Final EA – Additional Appendix Materials

Appendix G – Cultural Resources Consultation and Summary

Project: 221028007F – Air Tour Management Plan for Badlands National Park

Figure 1. Section 4(f) resources and location points in the Section 4(f) study area.

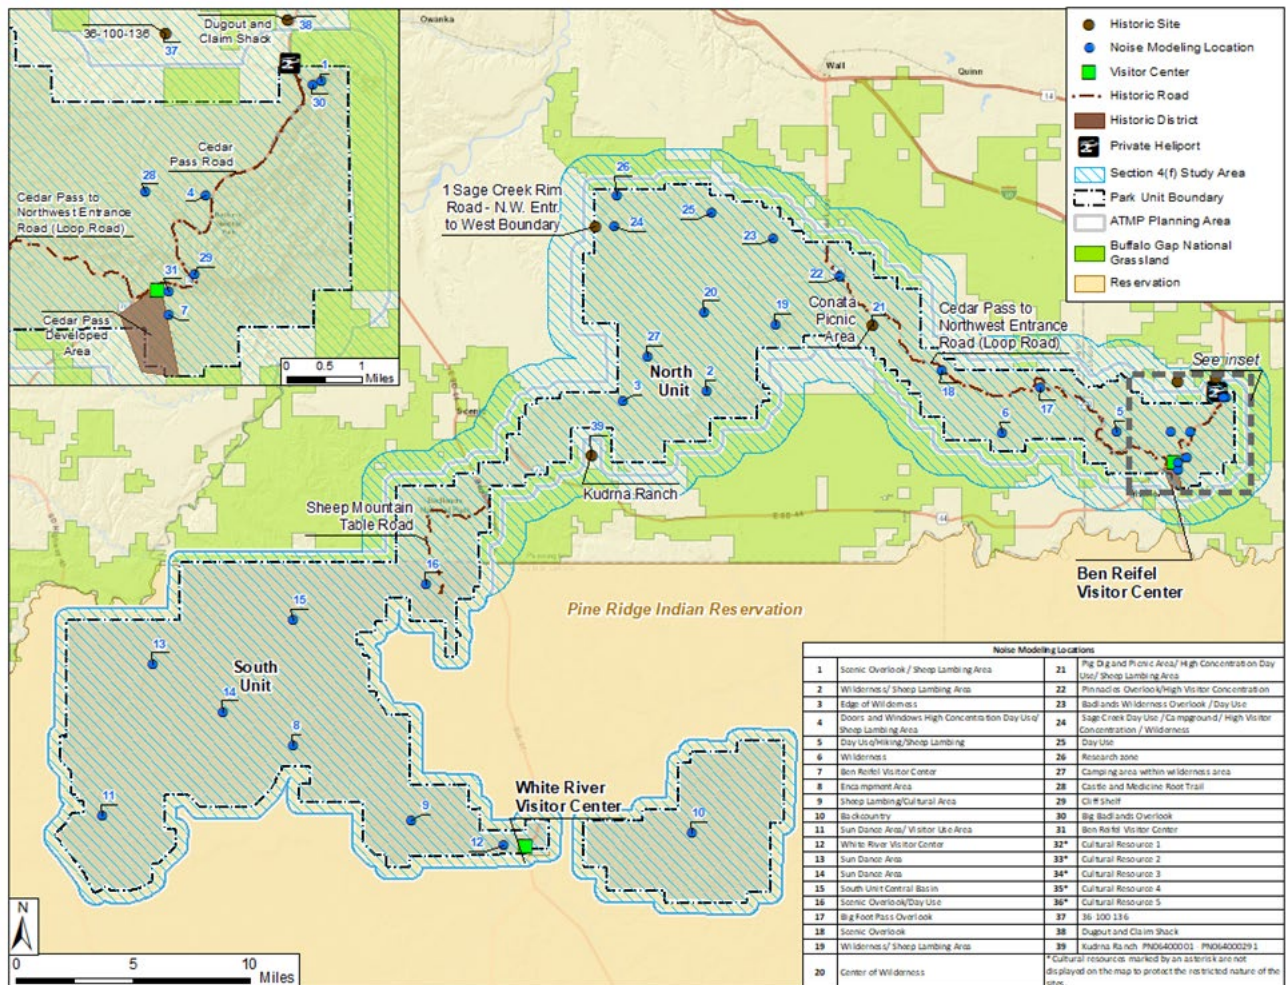
To assess time above 52 dBA at Section 4(f) resources under Alternatives 3 and 4, location points within 1.5 miles of each Section 4(f) resource were identified (Figure 1). The time above 52 dBA at location points and the range of time above 52 dBA at Section 4(f) resources based on nearby location points were then calculated and reported as high and low values. Table 1 shows the low and high modelled time above 52 dBA values under Alternative 3 and Alternative 4 at each Section 4(f) resource. Table 2 shows the distance between each Section 4(f) resource and nearby location point and the time above 52 dBA at the corresponding location point. A distance of 0.00 miles indicates that the location point falls within the Section 4(f) property. The longest time above 52 dBA in the Section 4(f) study area on days when air tours occur is 21.2 minutes under Alternative 3 and 8.6 minutes under Alternative 4.
